To:	Ken Kirwin Project Manager	Date:	December 8, 2016
From:	Hannah Brockhaus Howard Stein Hudson	HSH Project No.:	2015136.00
Subject:	Department of Conservation and Recreation Mount Auburn Street Corridor Study Stakeholder Group Meeting 6 Meeting Notes of November 1, 2016

## OPTION A: FRESH POND PARKWAY

**OPTION A: GERRY'S LANDING, MEMORIAL DRIVE, AND GREENOUGH BLVD**

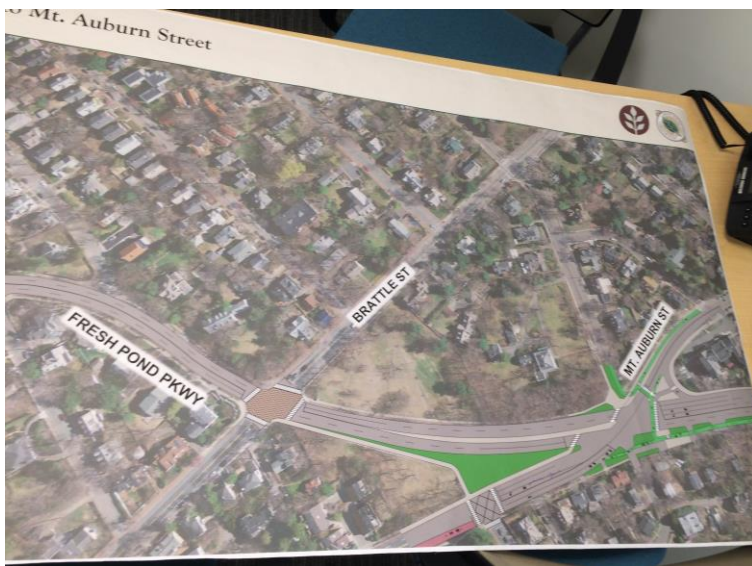
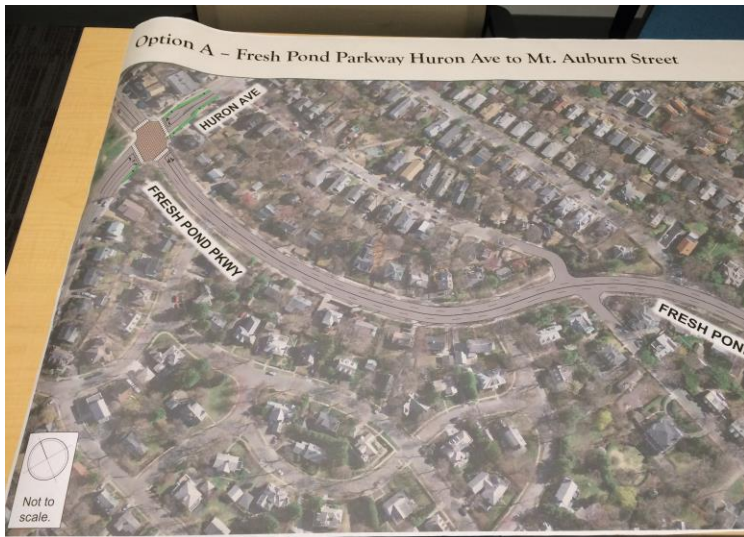
There were very few comments on this map. One comment expressed preference for the bus parking in front of BB&N (rather than parking).

**OPTION A: MOUNT AUBURN CORRIDOR**

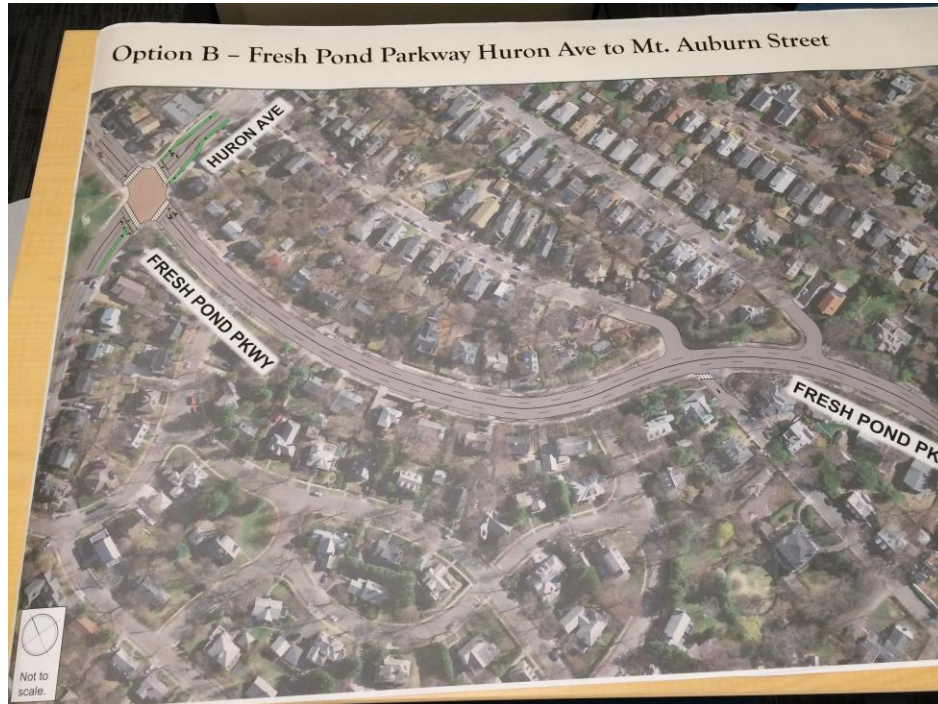
There were very few comments on this map. One comment expressed preference for the T-ed up intersection at Brattle.
